# Public Works Subcommittee Meeting on 7 January 2009 Issue Requiring Follow-up Actions by the Administration

### Item PWSC(2008-09)56

## 49RG - Public library and indoor recreation centre in Area 3, Yuen Long

AREA 3, YUEN LONG 元朗第3區公共圖書館及 KAH WONG **JAN 09** office 體育館 ARCHITECTURAL BRANCH

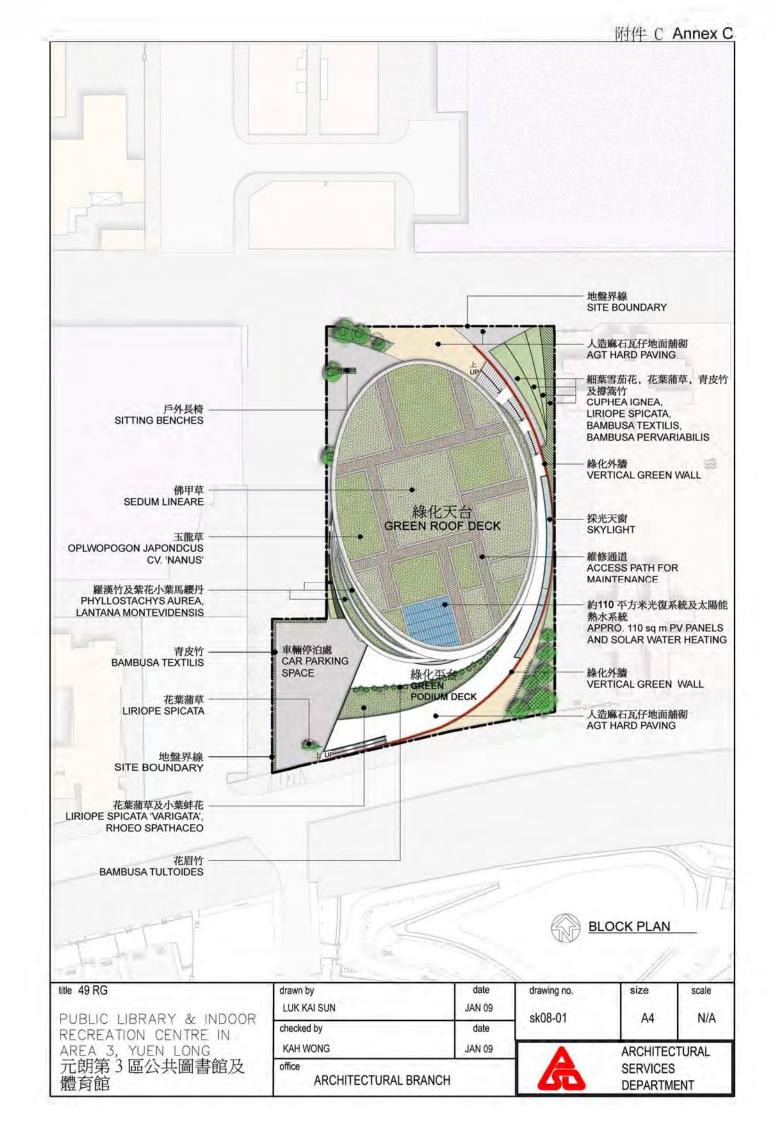
To address the concern of Prof Hon Patrick LAU about adequate provision of windows for the library, the reasons for locating the proposed indoor recreation centre above the library; and the request of Hon Albert CHAN and Hon KAM Nai-wai for enhancement of greening measures including vertical greening for the building, the Administration would provide, before the relevant FC meeting, further information including more detailed layout plans for members' reference.

Adequate provision of windows has been included in the design for the library to use natural sunlight to enhance the reading environment. Detailed layout plans showing the provision of windows for the library are set out at **Annexes A and B**.

The greening measures including vertical greening for the project are shown on the layout plans at **Annexes C and D**.
